**Re: Type B Water License #2BB-MRY0710
Mary River Project
Part J, Item 1 – Modification to Waste Disposal Facilities
Request for Board Approval**

Through this submission, Baffinland formally requests of the Board approval for a modification to the existing Waste Disposal Facilities at Milne Inlet and Mary River camps under Part J, Item 1 of 2BB-MRY0710. Baffinland proposes to increase temporary pond capacity through the provision of an additional two-cell pond at the Mary River camp and a single cell pond at the Milne Inlet camp. Design of this lined pond space is provided on attached drawings C701, C702, C801 and C802 stamped by a Professional Engineer licensed to practice in Nunavut.

MARY RIVER
PWSP #2
PLAN/PROFILE

Project
MILNE INLET PROJECT
BAFFIN LAND IRON
MINES CORP
BAFFIN ISLAND NUNAVUT
Drawing
MILNE INLET
PWSP #2
PLAN/PROFILE

SCALE 1:100

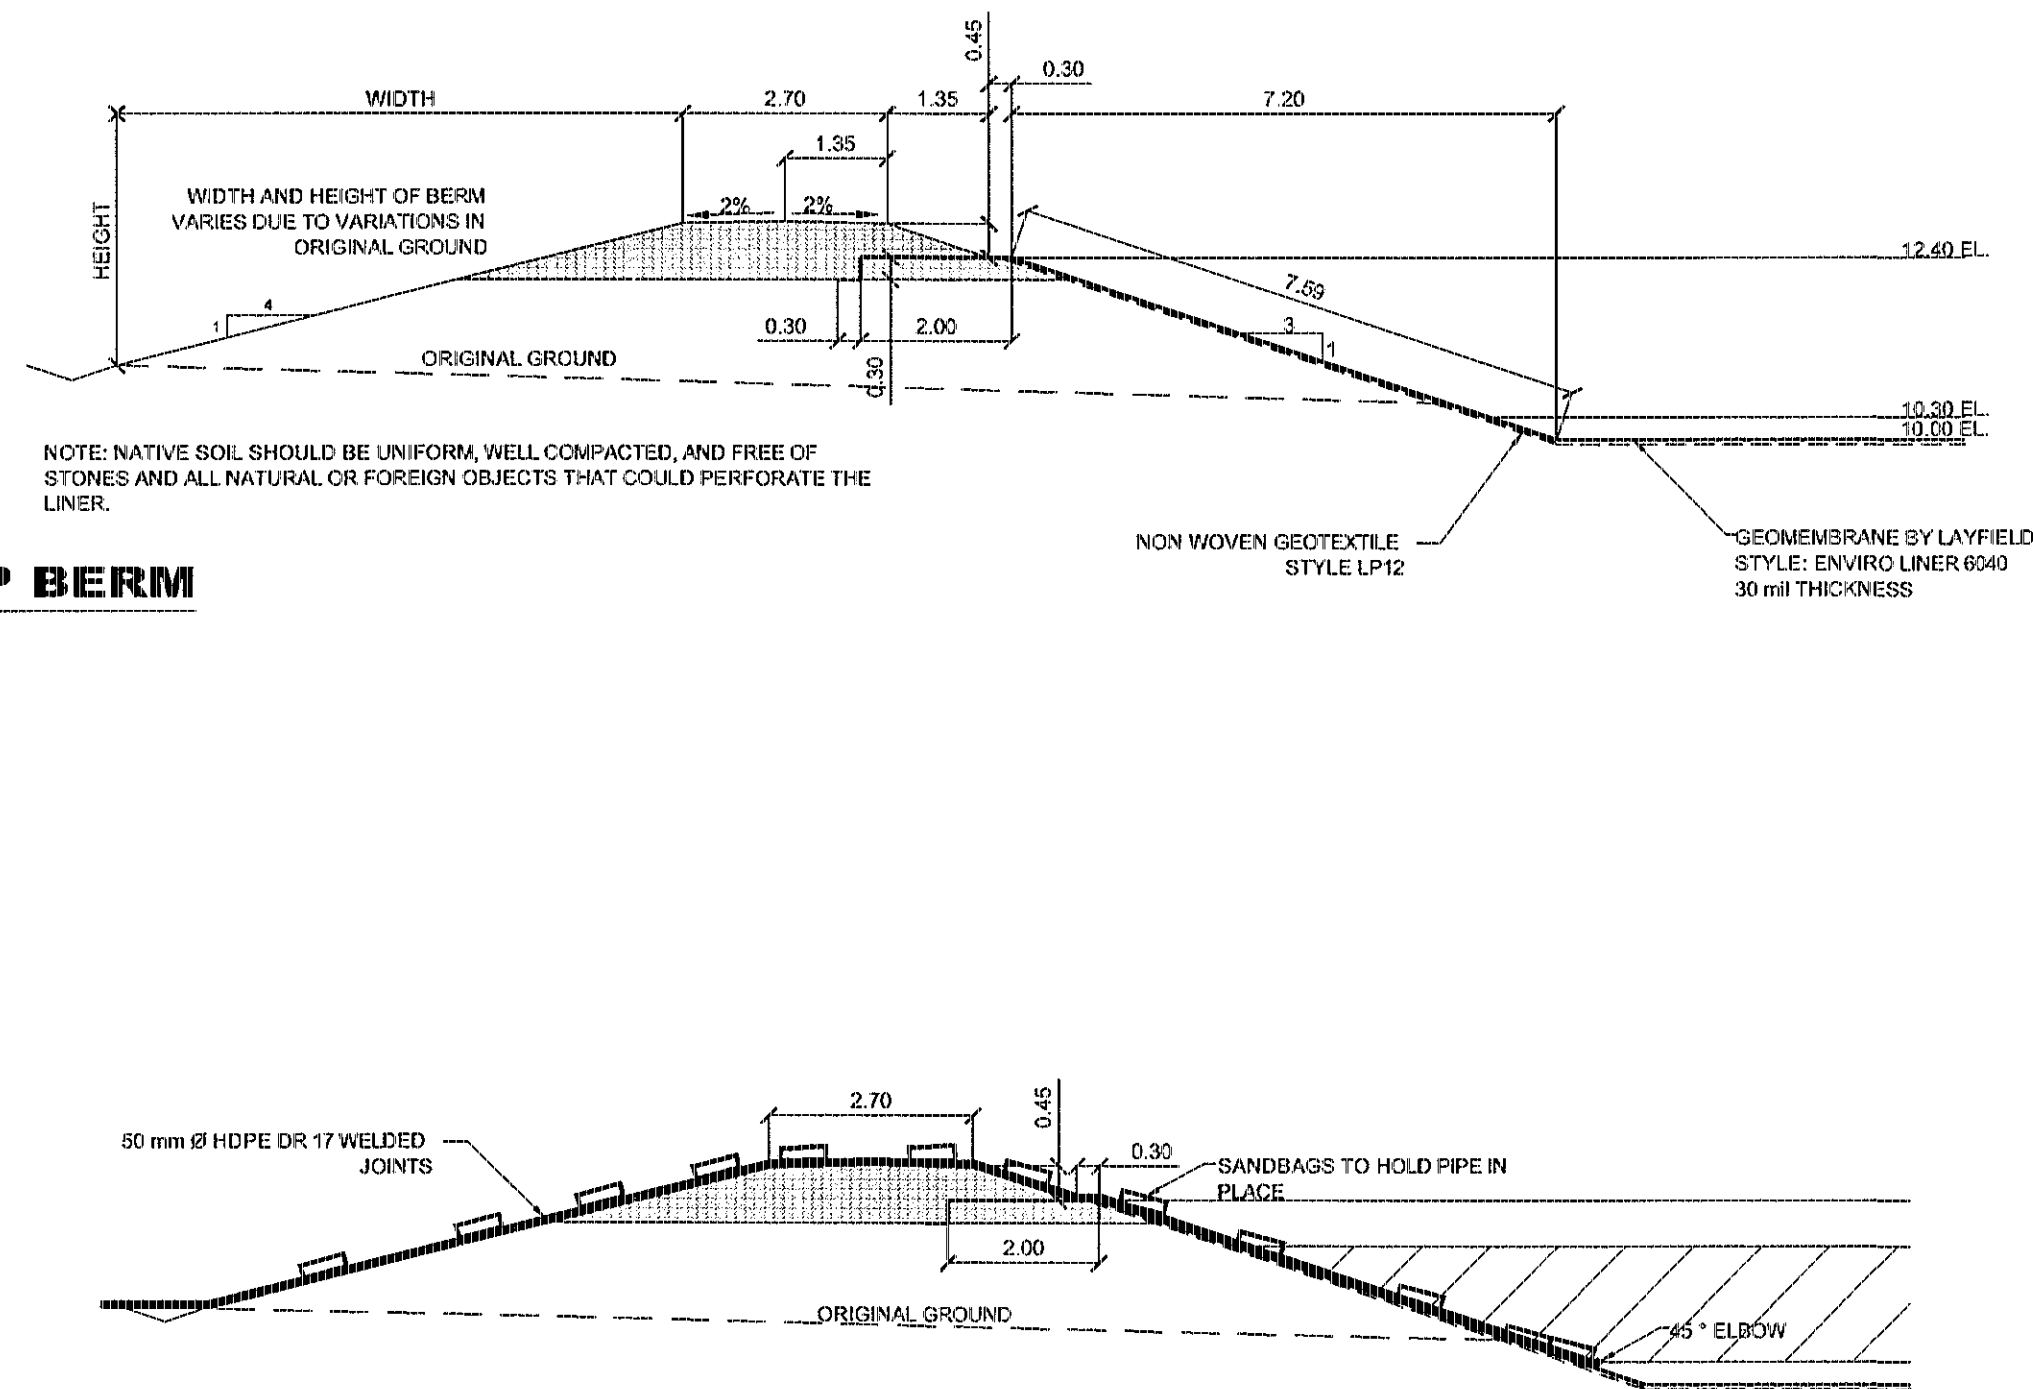
The 2nd cell at the Mary River camp and the single pond cell at the Milne camp are intended to provide further contingency in the event that pond space is not available to accept treated effluent during on-going operations due to system upsets during which average effluent requirements may not be consistently met. These ponds are identified as further contingency and may not be required depending on realized performance of the rotating biological contactors. However, Baffinland seeks approval to construct these ponds in the event they are indeed required.
